## **ITEM 2**

<b>Application Reference</b>	DC/090964
<b>Location:</b>	18-37 High Street Stockport SK1 1EG
<b>PROPOSAL:</b>	Partial demolition/conversion of existing buildings, the creation of a residential development (Use Class C3) comprising 45 units, landscaping, highway works and other associated infrastructure
<b>Type Of Application:</b>	Full
<b>Registration Date:</b>	29/01/24
<b>Expiry Date:</b>	11/07/24
<b>Case Officer:</b>	Chris Smyton
<b>Applicant:</b>	Britannia Stockport Ltd
<b>Agent:</b>	Miss Louisa Fielden, AshtonHale

## **COMMITTEE STATUS**

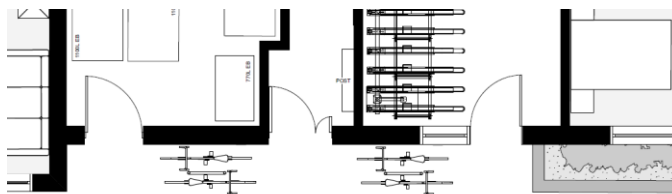
- 3) The revised scheme still only incorporates a single Sheffield stand for visitors, as opposed to the 2 that were originally proposed. As previously advised and as shown on the drawing below, it would be possible to provide a second stand between the main door to the new block and the door to the cycle store in that block. As such, I consider the provision of 2 visitor cycle stands could be dealt with by condition.

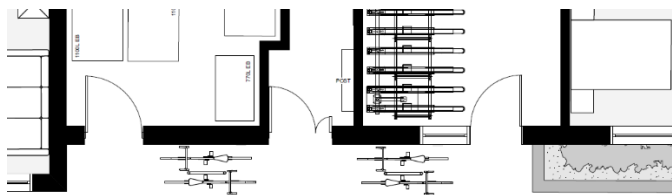
- 8) The revised scheme still only incorporates a single Sheffield stand for visitors, as opposed to the 2 that were originally proposed. As shown on the drawing below, it would be possible to provide a second stand between the main door to the new block and the door to the cycle store in that block. As such, I consider the provision of 2 visitor cycle stands could be dealt with by condition.

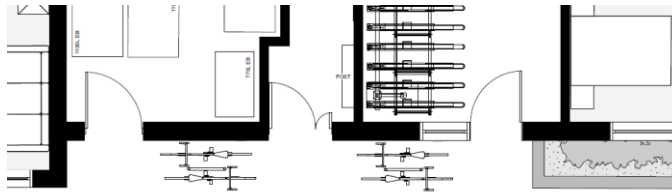
- 5) The revised scheme still only incorporates a single Sheffield stand for visitors, as opposed to the 2 that were originally proposed. As shown on the drawing below, it would be possible to provide a second stand between the main door to the new block and the door to the cycle store in that block. As such, I consider the provision of 2 visitor cycle stands could be dealt with by condition.
